UNITED STATES PATENT AND TRADEMARK OFFICE

APPLICATION NO.	FILING DATE	FIRST NAMED INVENTOR	ATTORNEY DOCKET NO.	CONFIRMATION NO.
10/789,689	02/27/2004	Takehiro Okanaka	KASAP047	9344

Office Action Summary

DETAILED ACTION

FIG. 9D

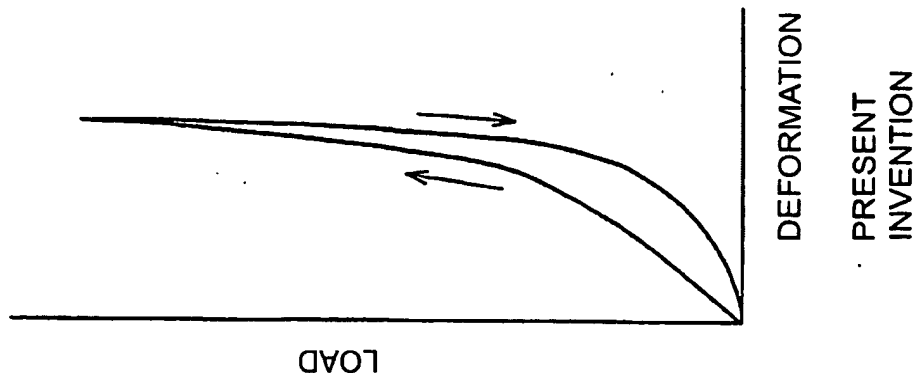
amendments to the specification and the drawings be accompanied to the Response to this Office Action. Applicant amended figures 9A, 9B, 9C, 10A, 10B, 11A, 11B, 11C, 11D, 12C, 12D, 12E and 12F to include labels "Comparative Example 1", etc. in the Response dated 6/30/05. These labels do not specifically identify these figures as prior art or as different embodiments of the present invention. Hence, the objection is repeated above for figures 9A, 9B, 9C, 10A, 10B, 11A, 11B, 11C, 11D, 12C, 12D, 12E and 12F. The amended figures 9D, 12A and 12B including labels "Present Invention" have been approved.

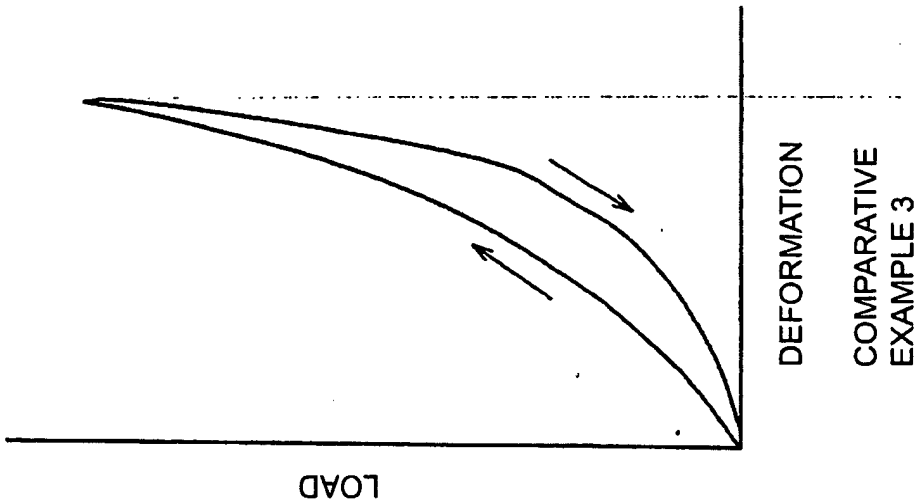
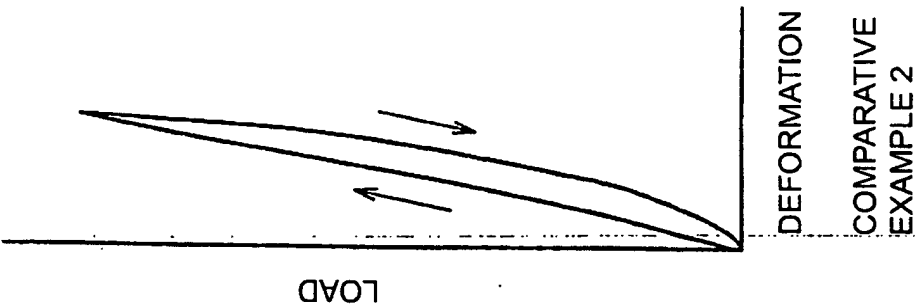
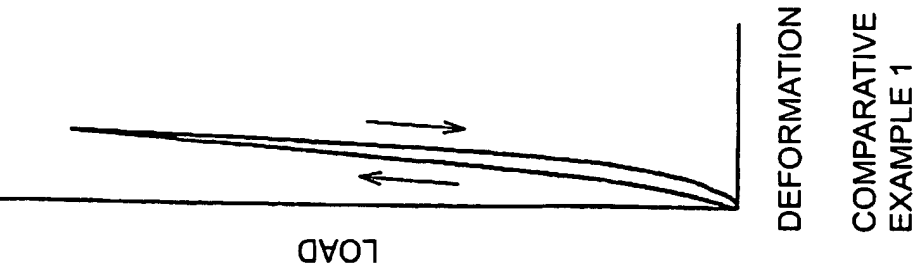
2. It is unclear about the status of figures 9A, 9B, 9C, 10A, 10B, 11A, 11B, 11C, 11D, 12C, 12D, 12E and 12F. It appears from the specification that these figures should be prior art since they are similar to the stopper of figure 13, the stopper of JP9-166175 and the stopper of JP2001-349368. However, Applicant fails to specify that these figures are prior art or not. Furthermore, Applicant does not specify that these figures represent different embodiments of the instant invention. In fact, the specification only mentioned one embodiment of the instant invention in figures 1, 2, 3, 4, 5, 6, 7A, 7B, 8A, 8B, 8C, 9D, 12A and 12B. It is required that an explanation and/or

NOT approved
XLN
9/6/05

Corrected drawing sheets in compliance with 37 CFR 1.121(d) are required in reply to the Office action to avoid abandonment of the application. Any amended replacement drawing sheet should include all of the figures appearing on the immediate prior version of the sheet, even if only one figure is being amended. The figure or figure number of an amended drawing should not be labeled as "amended." If a drawing figure is to be canceled, the appropriate figure must be removed from the replacement sheet, and where necessary, the remaining figures must be renumbered and appropriate changes made to the brief description of the several views of the drawings for consistency. Additional replacement sheets may be necessary to show the renumbering of the remaining figures. Each drawing sheet submitted after the filing date of an application must be labeled in the top margin as either "Replacement Sheet" or "New Sheet" pursuant to 37 CFR 1.121(d). If the changes are not accepted by the examiner, the applicant will be notified and informed of any required corrective action in the next

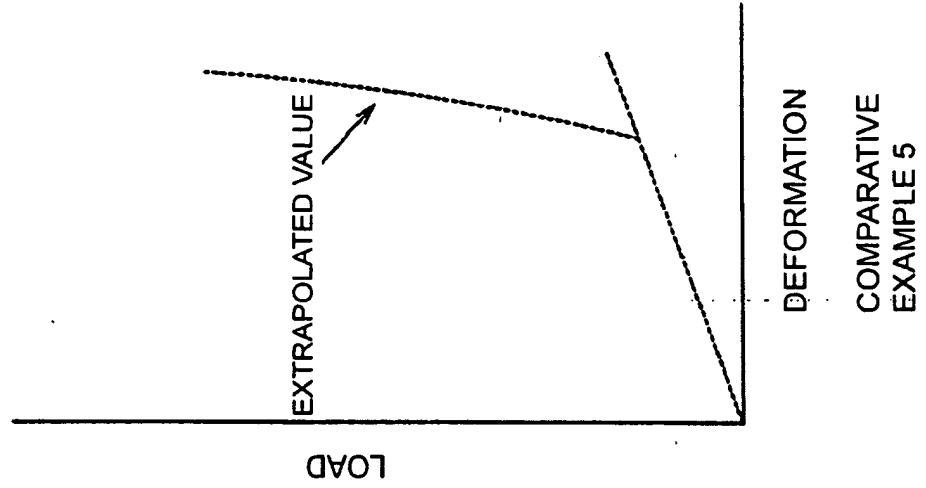
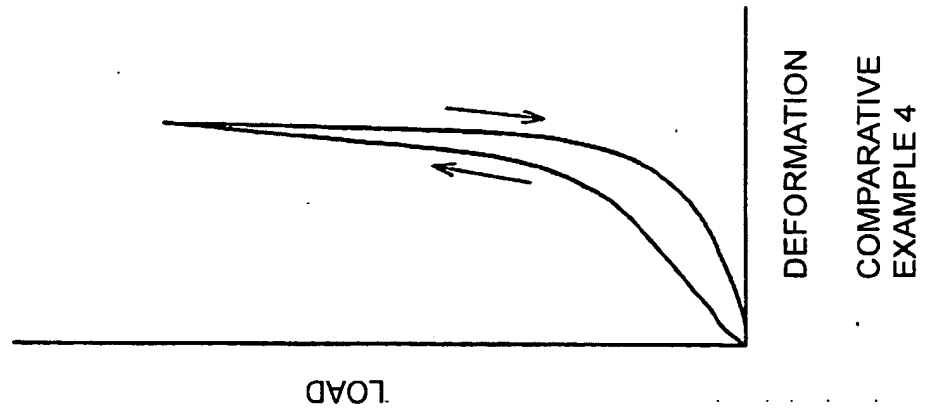
NOT approved
XLN
9/6/05

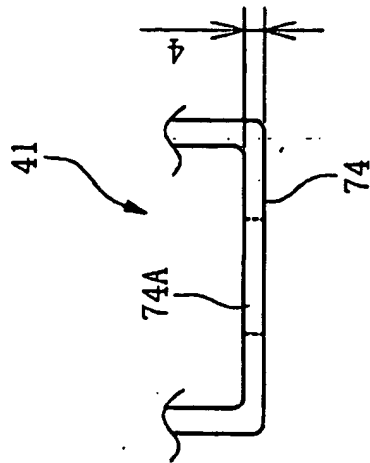
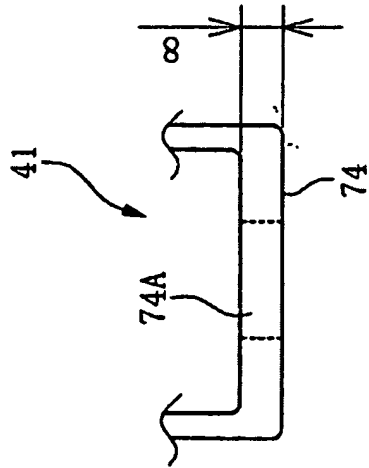
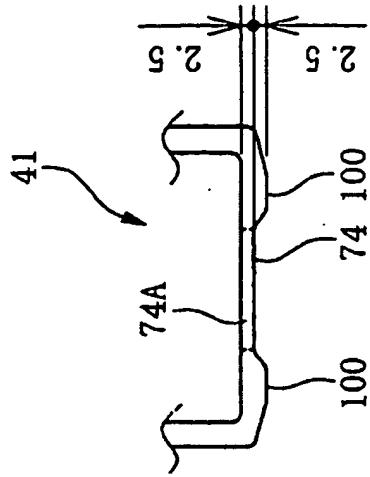
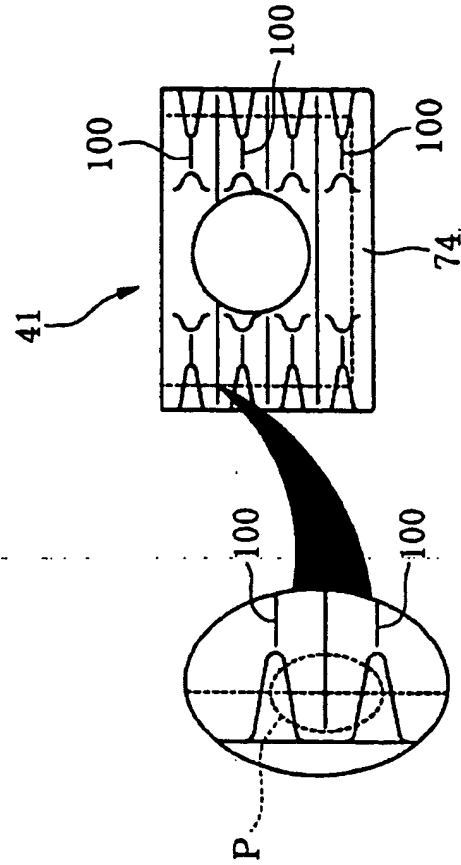
NOT approved
XLN
9/6/05

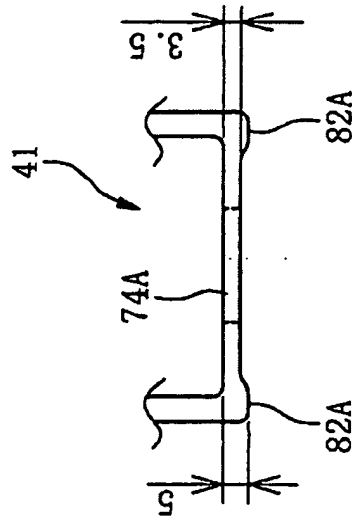
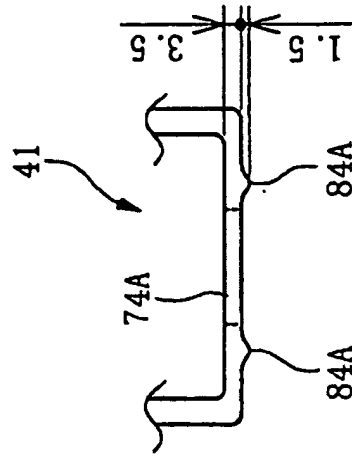
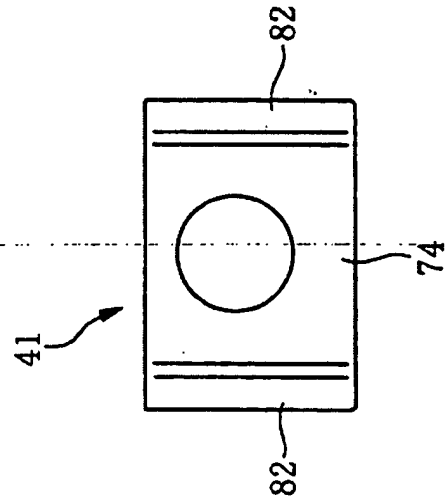
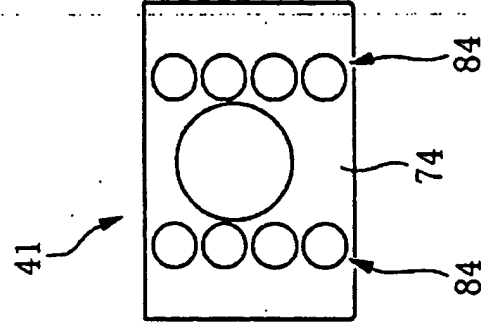
Not approved
XLN
9/6/05

FIG. 13

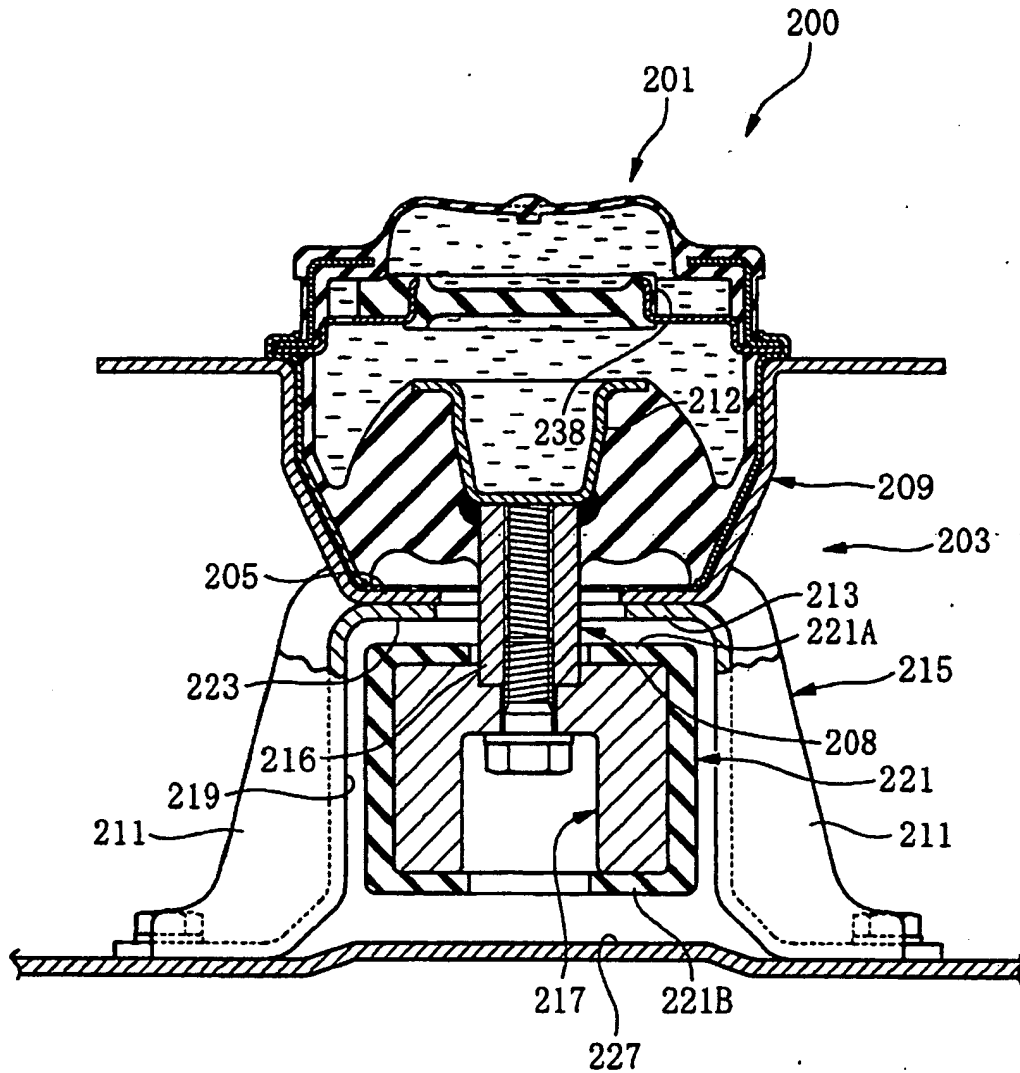
NOT approved
XW
9/6/05
